## Product Change Notice (PCN)

PCN Number: PCN-0451169R-01

Product(s) Affected: PJ-043H

F-723-001

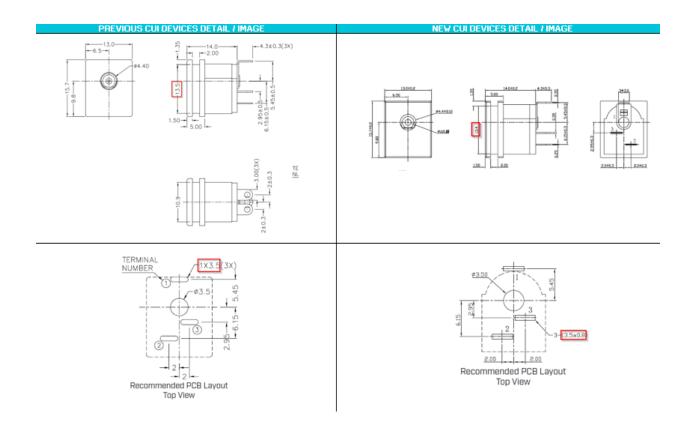
Description of Change: *Minor Housing and footprint differences*. *Material Change on the housing and terminals*. See image Below

PREVIOUS CUI DEVICES DETAIL / IMAGE		IMAGE	NEW CUI DEVICES DETAIL / IMAGE		
	MATERIAL	PLATING	DESCRIPTION	MATERIAL	PLATING/COLOF
center pin	copper	nickel	center pin	brass	nickel
terminal 1	brass	silver	terminal 1	brass t=0.35	silver
terminal 2	copper alloy	silver	terminal 2	bronze t=0.25	silver
terminal O	brass	alluar	terminal 3	brass t=0.35	silver
MATING PLUG Jack Insertion Depth 9.50 mm			MATING PLUG Jack Insertion Depth; 9.0 mm
